LINCOLN CITY/LANCASTER COUNTY PLANNING STAFF REPORT

for April 26, 2006 PLANNING COMMISSION MEETING

PROJECT #: Use Permit #06004 - Yankee Ridge Commercial Center

PROPOSAL: A 224,000 square foot commercial center including retail, bank with drive-through, general commercial and restaurants.

Target Site Design

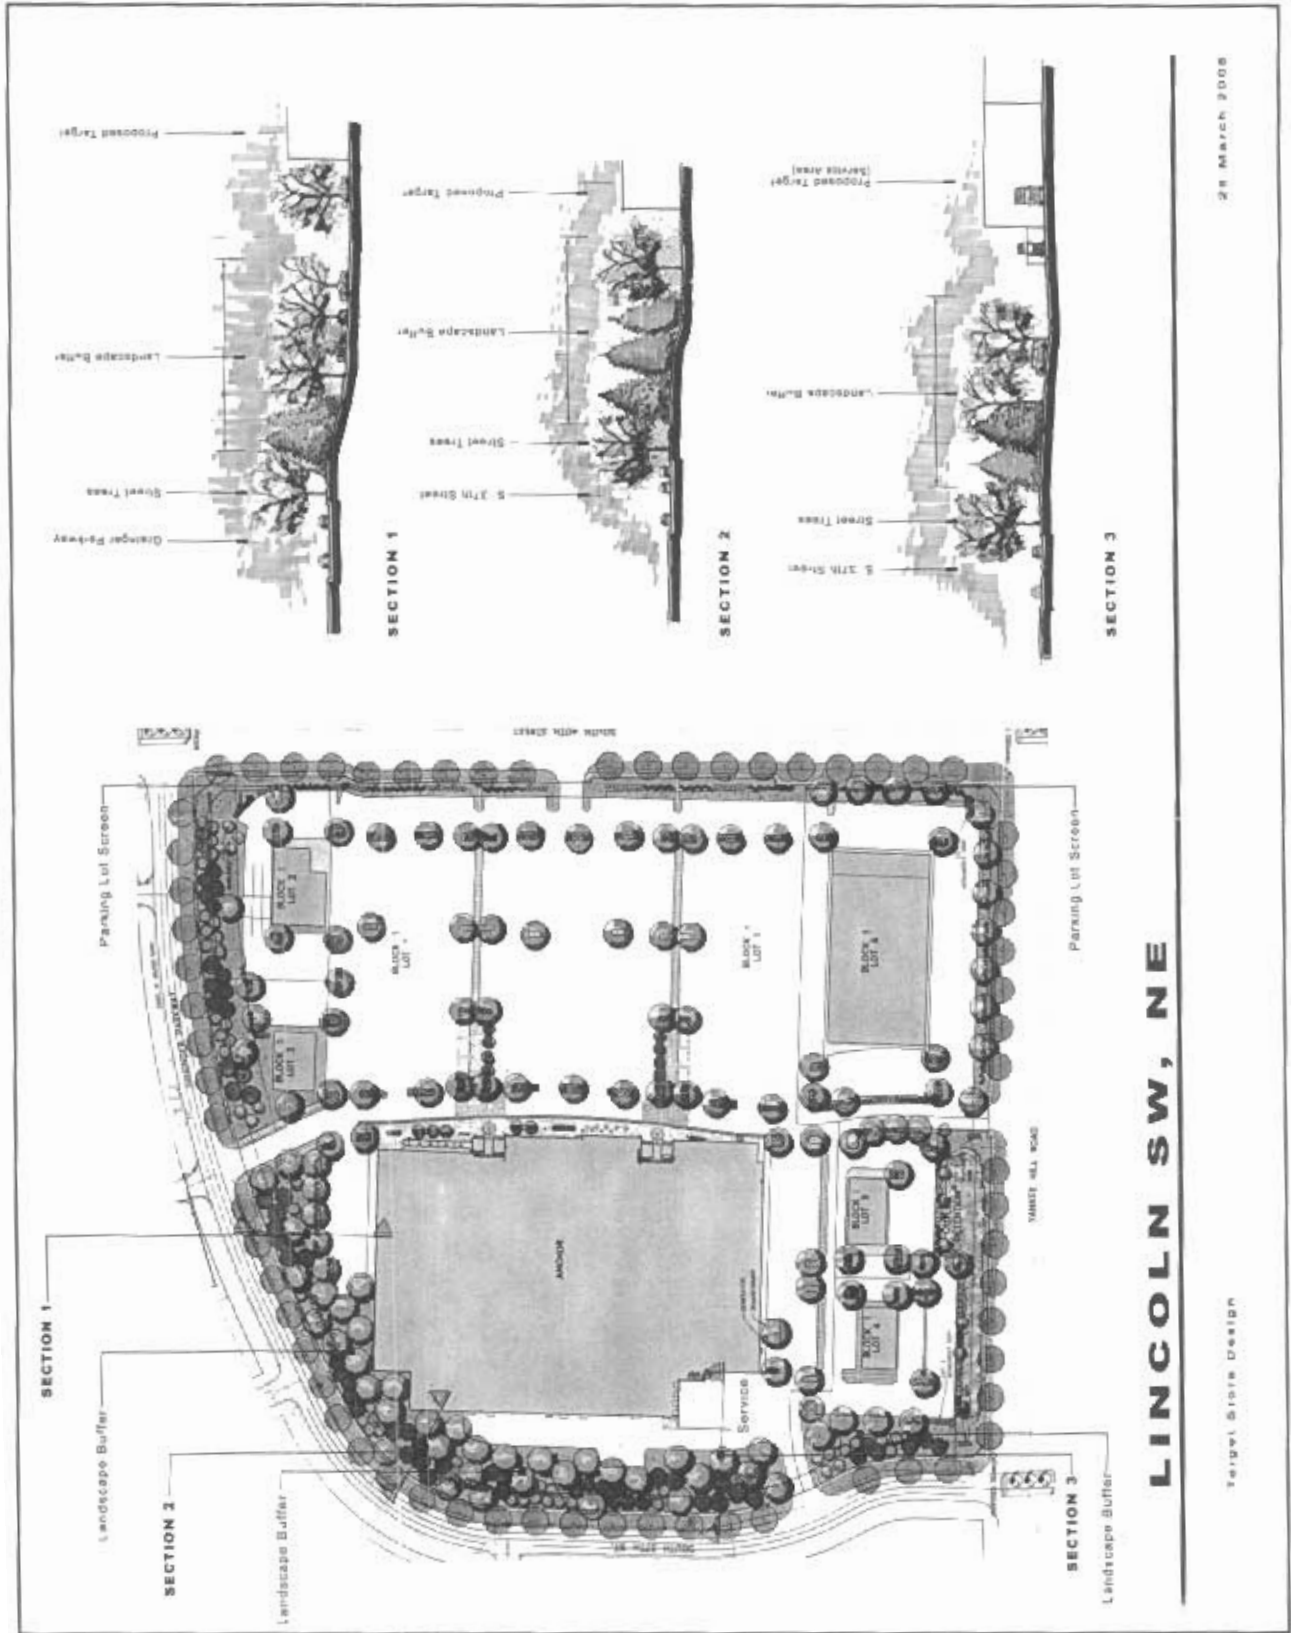
Beyond the requested modification to locate identification signs more than 30' from a building, there are no other adjustments and signs are to be installed per the requirements of the Zoning Ordinance and Sign Code. As a result, the two signs identified as "Anchor Store Sign" are unnecessary and may cause confusion if left on the site plan.

6. Access to the site is provided by driveways onto adjacent public streets, and no new public streets or private roadways are shown. Internal access is provided by a system of private drives over public access easements. It is important that the proposed driveways align with existing streets or drives to minimize traffic conflicts. It is not clear if the drive onto South 37th Street aligns with the drive to the west entering the Sterling Hills development. The plans must be revised to show the drive to the west and the proper drive alignment.

The drive onto South 40th Street is aligned with a parking lot median. This requires cars to immediately execute a turning movement upon entering the site, and does not provide any space for vehicle stacking for cars exiting the site. The drive should be moved slightly to align with a driving aisle through the parking lot.

9. A loading area is shown on the west side of the building and includes a vehicle parking area. A facility to allow vehicles to turn around and exit is required.

10. The Health Department notes the existence of a 12" high-pressure, underground natural gas pipeline south of this development. There are no requirements for regulating land uses adjacent to it, however the Health Department recommends the location be noted on the site plan to help serve notice to affected parties.

11. The Comprehensive Plan shows the bike trail system along Yankee Hill Road in this area. The sidewalk along Yankee Hill Road needs to be expanded to reflect a 10'-wide bike trail. An additional 6' of right-of-way must be dedicated to accommodate this wider sidewalk.

- 2.1.1.4 Delete General Notes 15 and 23.

- 2.1.1.5 Delete the text and symbols indicating "Anchor Store Sign."
- 2.1.1.6 Show the South 40th Street driveway aligned with parking aisles, and the South 37th Street driveway aligned to the satisfaction of Public Works and Utilities.

- 2.1.1.7 Revise General Note #22 to state "A COMMON ACCESS EASEMENT SHALL BE GRANTED OVER ALL DRIVES AND PARKING STALLS."
- 2.1.1.8 Revise General Note #24 to state "NO BUILDING OR PARKING SHALL BE ALLOWED IN THE 50'-WIDE LANDSCAPE BUFFER ADJACENT TO SOUTH 37TH STREET OR GRAINGER PARKWAY."

- 2.1.1.9 Delete waiver #1.
- 2.1.1.10 Show a vehicle turn-around in the loading area on the west side of the anchor building.
- 2.1.1.11 Show the location of the high-pressure gas line.

- 2.1.1.12 Show the bike trail along Yankee Hill Road and any required additional right-of-way.
- 2.1.1.13 Revise the last line of General Note #13 to state "SIGNS TO CONFORM TO THE ZONING ORDINANCE, EXCEPT THAT WALL SIGNS SHALL NOT BE ALLOWED ON THE NORTH AND WEST WALLS OF THE ANCHOR STORE."
